STATE OF CONNECTICUT  
CONNECTICUT SITING COUNCIL

APPLICATION OF NEW CINGULAR WIRELESS  
PCS, LLC (AT&T) FOR A CERTIFICATE OF  
ENVIRONMENTAL COMPATIBILITY AND PUBLIC  
NEED FOR THE CONSTRUCTION, MAINTENANCE  
AND OPERATION OF A TELECOMMUNICATIONS  
TOWER FACILITY ON PROPERTY LOCATED AT  
560 WEST HILL ROAD IN THE CITY OF  
STAMFORD, CONNECTICUT

DOCKET NO. 447

NEW CINGULAR WIRELESS, PCS LLC (AT&T) RESPONSES TO CONNECTICUT  
SITING COUNCIL PRE-HEARING QUESTIONS SET I

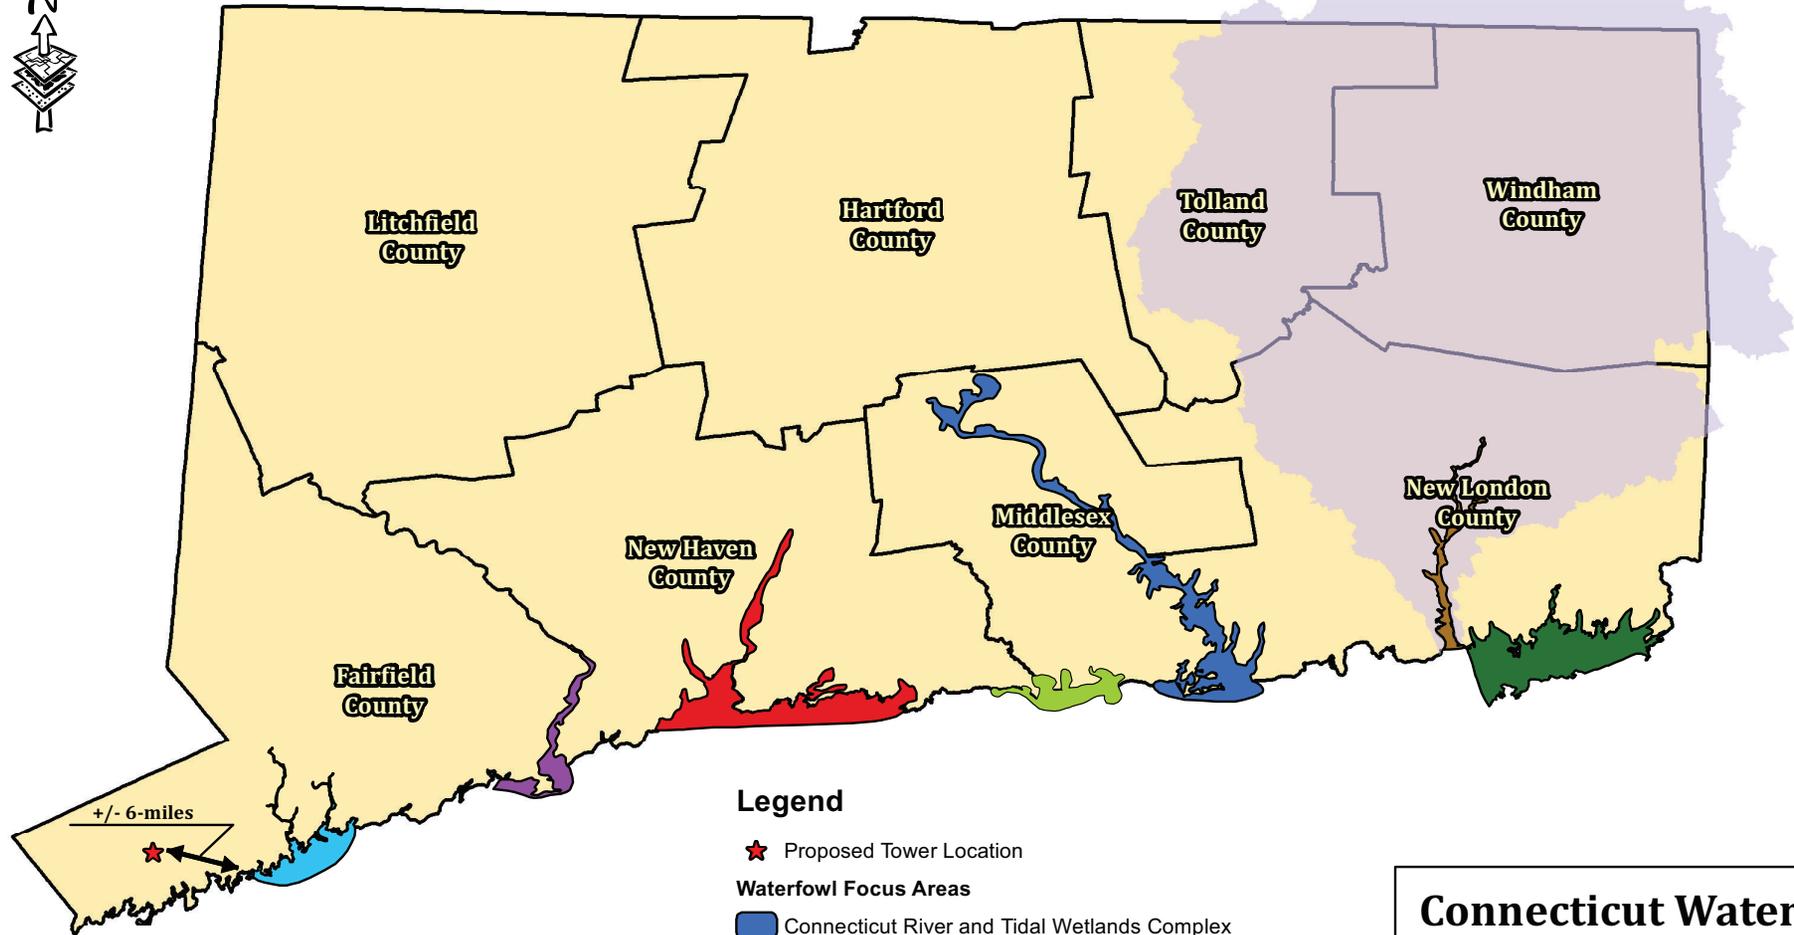
- Question #41 – *Is the proposed site near an “Important Bird Area” as designated by the National Audubon Society?*
- Question #42 – *Would AT&T’s proposed facility comply with recommended guidelines of the United States Fish and Wildlife Service for minimizing the potential for telecommunications towers to impact bird species?*

The National Audubon Society has identified 27 Important Bird Areas (“IBAs”) in the state of Connecticut. IBAs are sites that provide essential habitat for breeding, wintering, and/or migrating birds. The IBA must support species of conservation concern, restricted-range species, species vulnerable due to concentration in one general habitat type or biome, or species vulnerable due to their occurrence at high densities as a result of their congregatory behavior<sup>1</sup>. The closest IBA to the host Property is Cove Island Park in Stamford located approximately 3.5 miles to the southeast. The 83-acre park, owned by the City of Stamford, contains a diversity of habitats that is rare in the Stamford area. The park provides important habitat for migratory birds along the Connecticut coastal migratory flyway, resulting in an exceptional concentration of migratory landbirds during the spring and fall migrations. Due to its distance from the site, this IBA would not experience an adverse impact resulting from the proposed development of the Facility.

# Natural Diversity Data Base Map

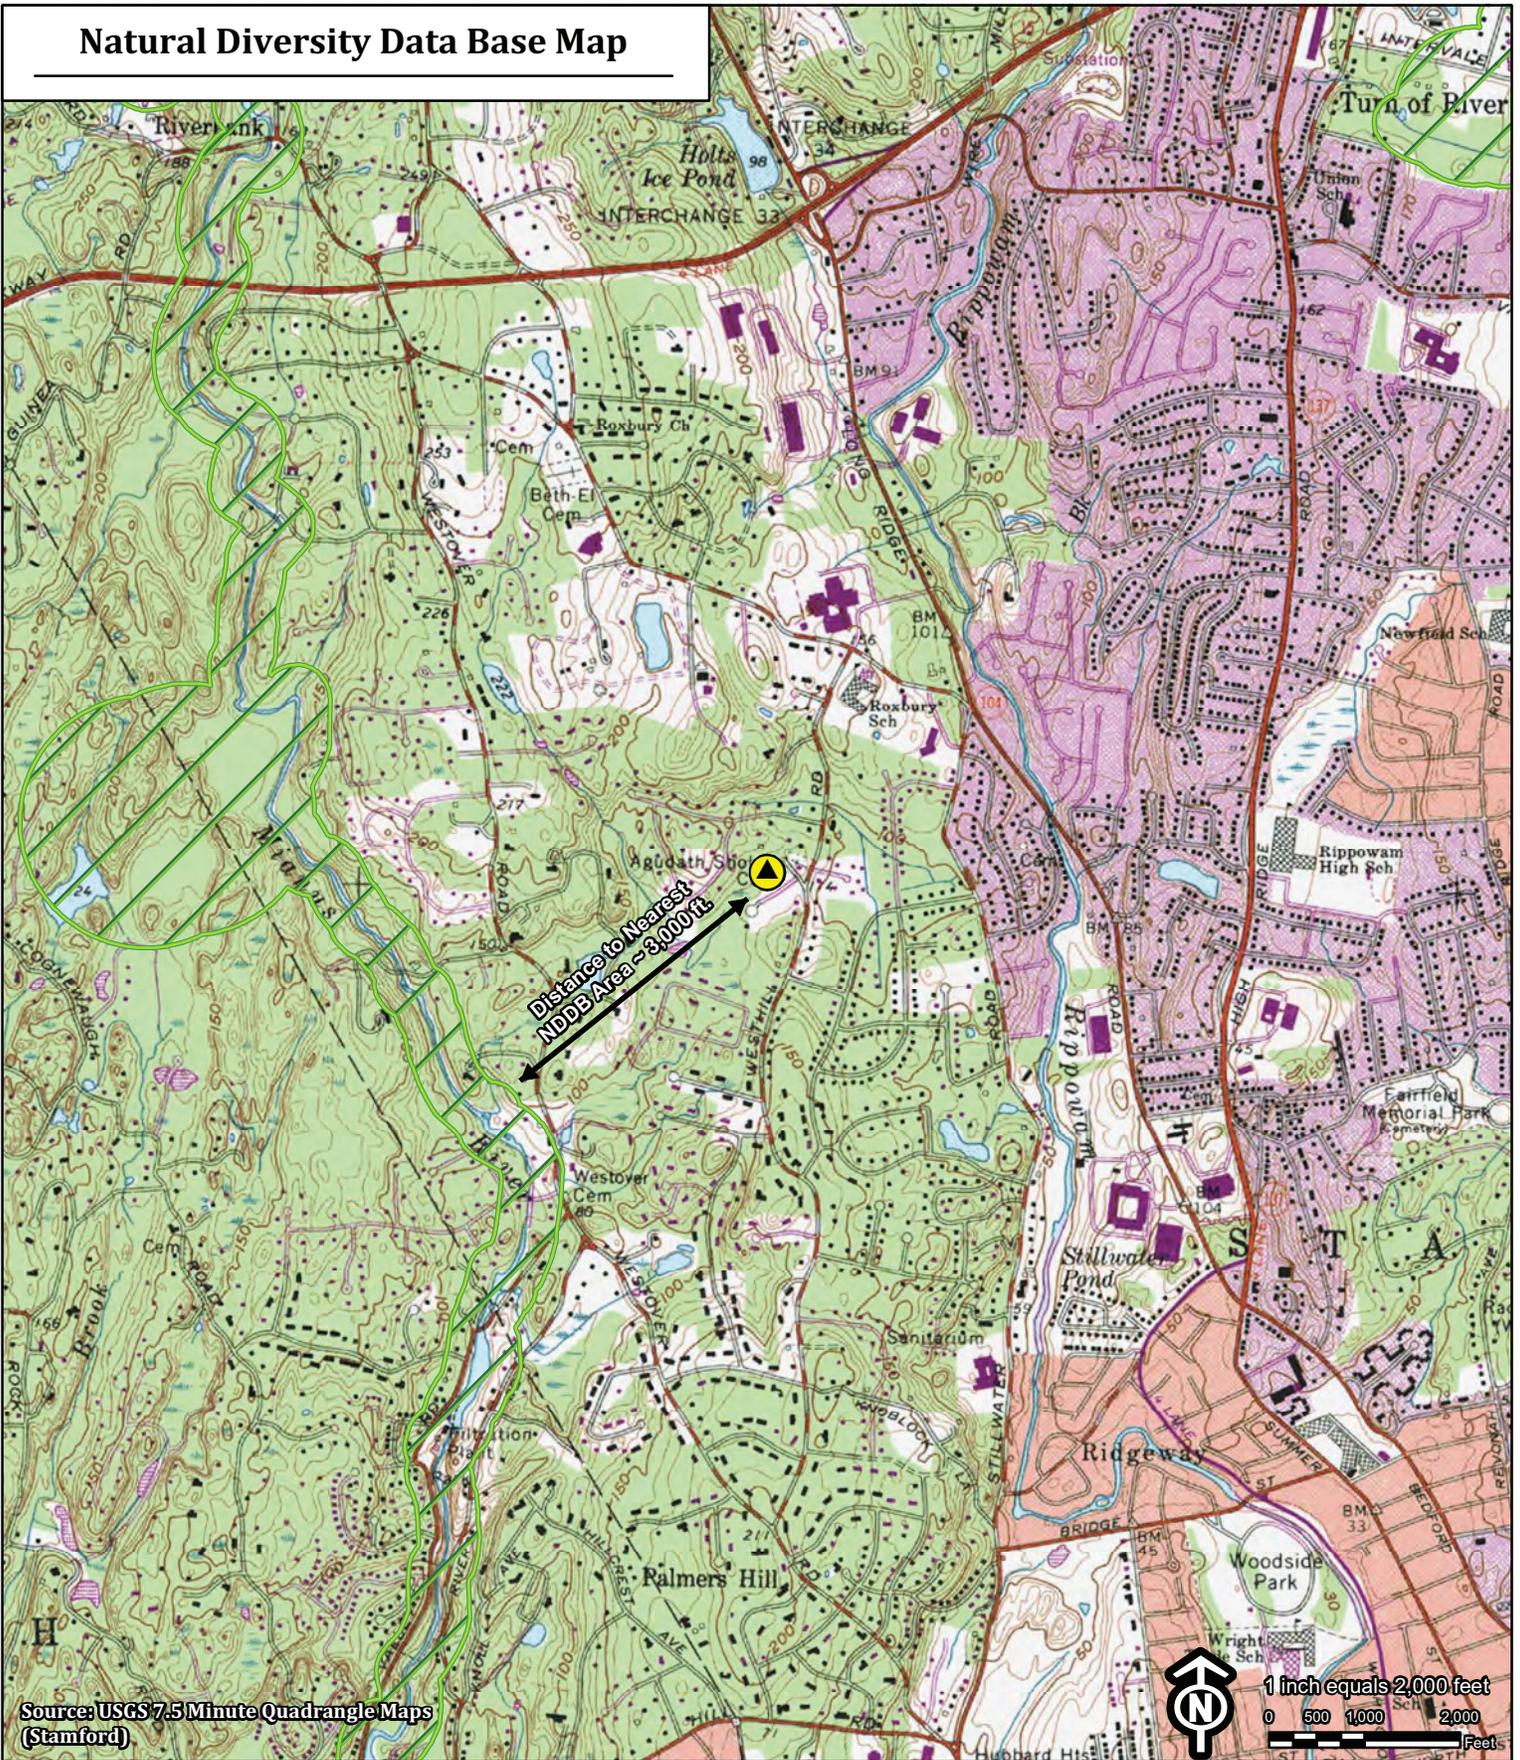
- A42. *Yes. Please refer to the Avian Resources Evaluation provide in Attachment 2*
- Q43. Is the site located within the shaded area of the State of Connecticut Department of Energy and Environmental Protection Natural Diversity Database? Explain.

- A43. *No, the site is not located within a Natural Diversity Data Base ("NDDDB") Area. The nearest NDDDB Area is located approximately 3,000 feet southwest of the site associated with the Mianus River riparian corridor. A NDDDB Map is provided in Attachment 3.*

By:	PAL		Project No.:	18301.1041.43000		
Project Name:	AT&T Stamford		Sheet:	2	of	2
Project Location:	Stamford, CT		Date:	April 18, 2014		
Subject:	NOISE LEVEL AT PROPERTY LINE BASED ON TWO AC UNITS

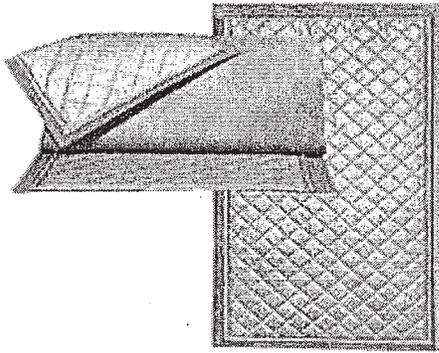
Q47. What is the expected cumulative noise level at the nearest property line from the proposed facility assuming the generator and air conditioning units are running at the same time? Provide a similar analysis only taking into account the air conditioning units.

Limit (dba)	Actual (dba)	Difference	Complies?
Day	55	69.91	14.91	NO
Night	45	69.91	24.91	NO

PROVIDE NOISE BARRIER TO REDUCE NOISE LEVELS
